[Docket No. 99–SW–81–AD; Amendment 39–11901; AD 2000–18–14]

Airworthiness Directives; Sikorsky Aircraft-Manufactured Model CH–54A Helicopters

ACTION: Final rule.

2000-18-14 Siller Helicopters; Aviation International Rotors, Inc. (AIR, INC); Columbia Helicopters, Inc.; Chet Raspberry, Inc. (CRI); Silver Bay Logging, Inc.: Amendment 39-11901. Docket No. 99-SW-81-AD. Supersedes AD 99-07-16, Amendment 39-11102, Docket No. 97-SW-60-AD.

Rework of Second Stage
Lower Planetary Plate (6435-20229-102)
Figure 1

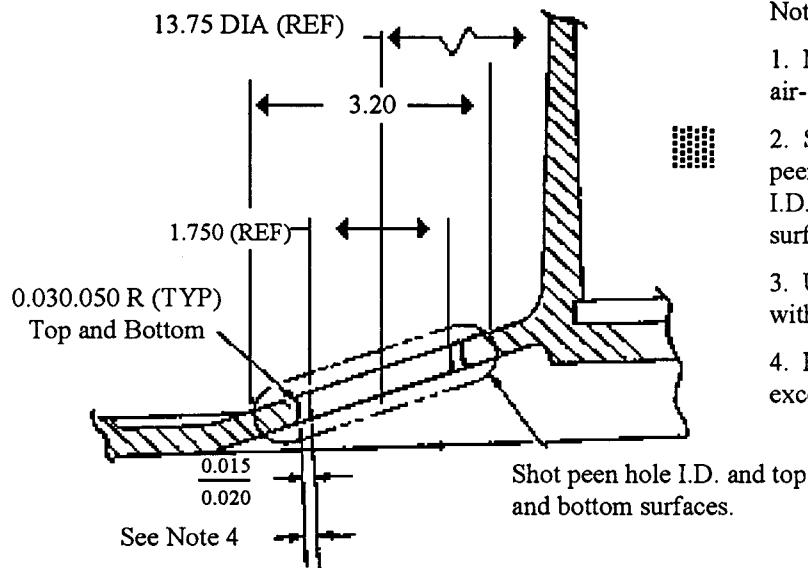
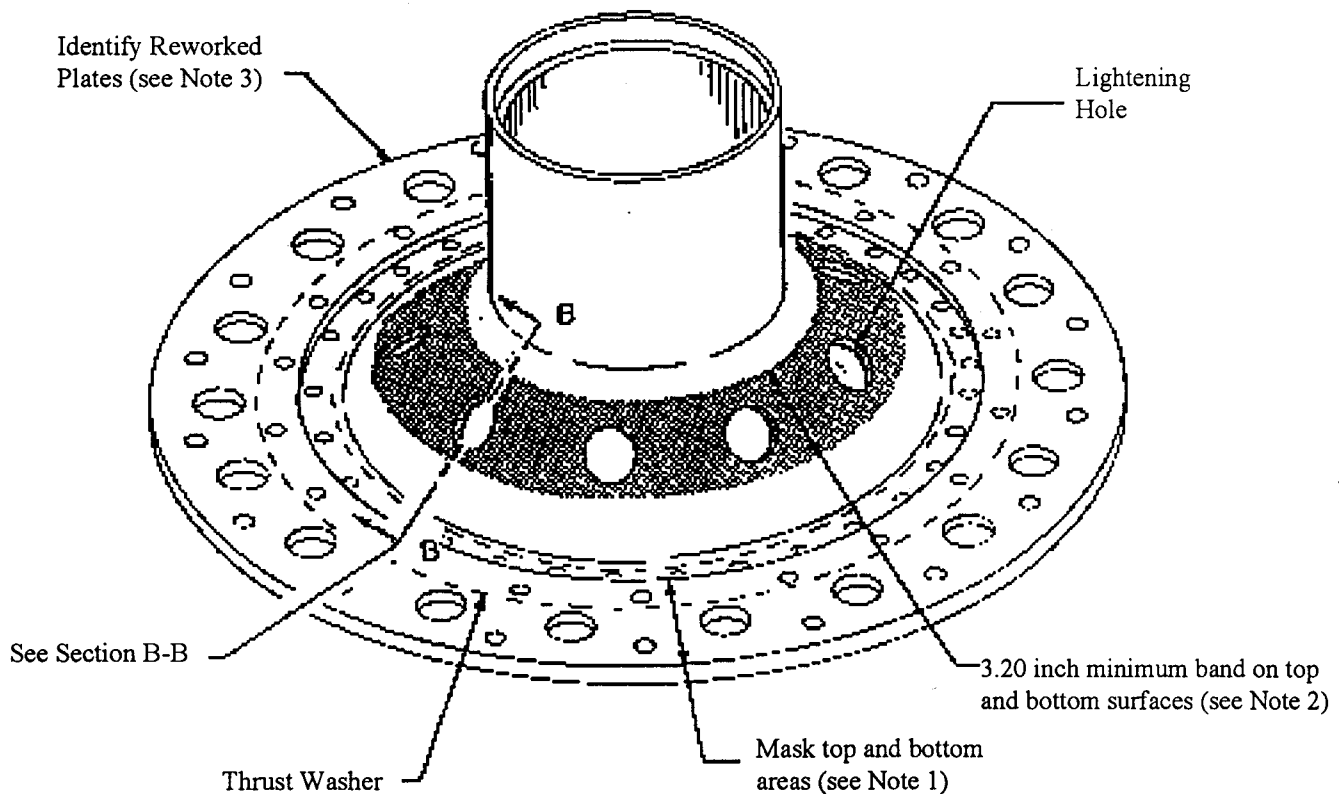
(2) If no crack is discovered, rework the plate as follows:

(i) Locate the center of each 1.750 inch-diameter lightening hole and machine holes 0.015 to 0.020 oversize on a side (0.030 to 0.040 diameter oversize). Machined surface roughness must not exceed 63 microinches AA rating (see Figure 1).

(ii) Radius each hole 0.030 to 0.050 inches on each edge as shown in Figure 1.

(iii) Mask the top and bottom surfaces of the plate to expose 3.20 inch minimum width circumferential band as shown in Figure 1.

(viii) Identify the reworked plate by adding "TS-107" after the part number using a low-stress depth-controlled impression-stamp with a full fillet depth of not more than 0.003 inch (see Figure 1).

1. Mask top and bottom areas to protect from liquid air-grit and shot peen.
2. Shaded area to be liquid air-grit blasted and shot peened includes plate top and bottom surfaces and I.D. of all lightening holes. Feather shot peened surface edges.
3. Use low-stress depth controlled impression-stamp with full fillet depth of no more than 0.003 inch.
4. Reworked machined surface roughness shall not exceed 63 microinches AA rating.

**Borescope Inspection of
Second Stage Lower Planetary Plate
Figure 2**

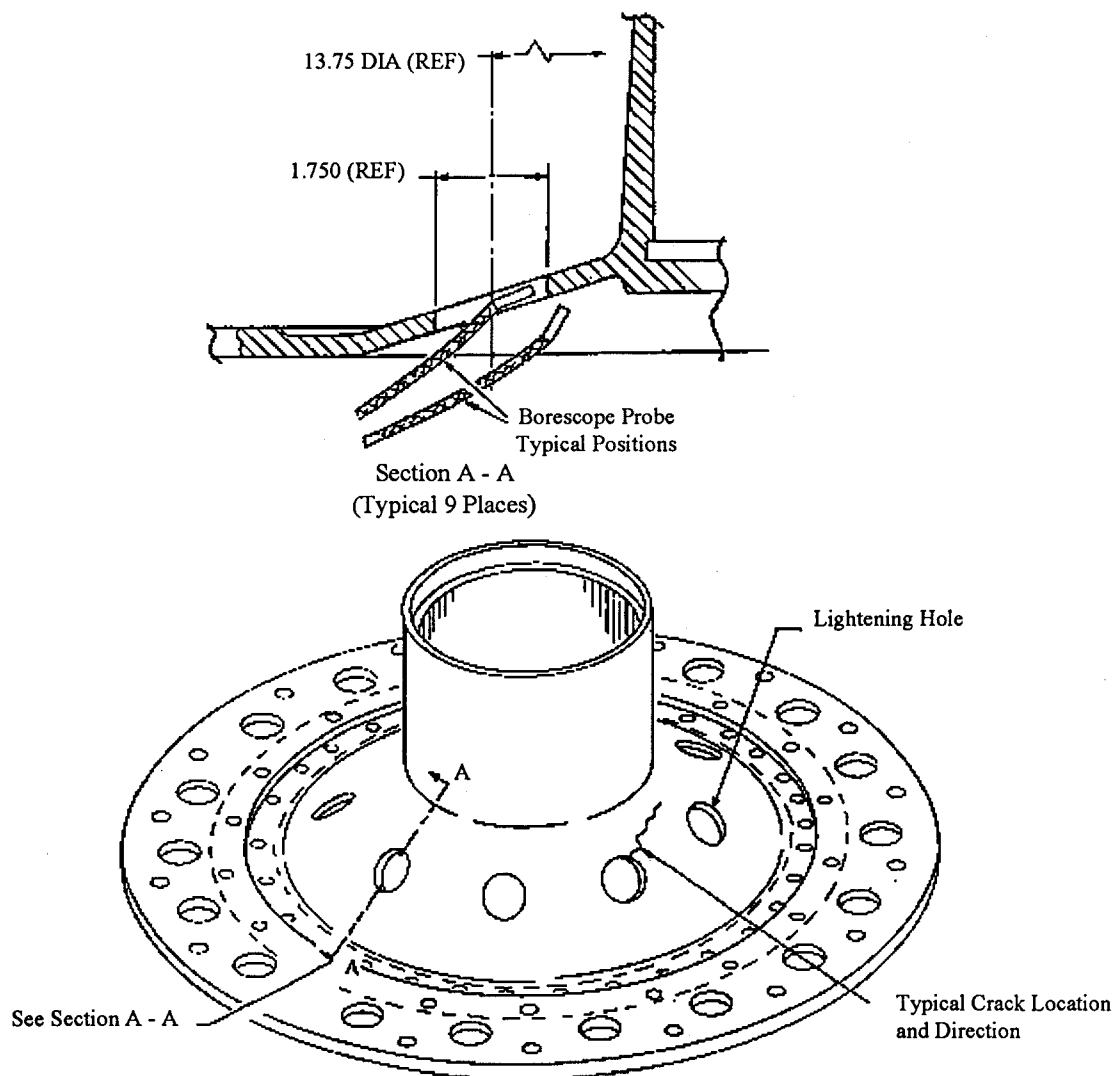
(1) Inspect the plate for a crack in the area around all nine lightening holes using a Borescope or equivalent inspection method (see Figure 2).

(2) If a crack is found, replace the plate with an airworthy plate prior to further flight.
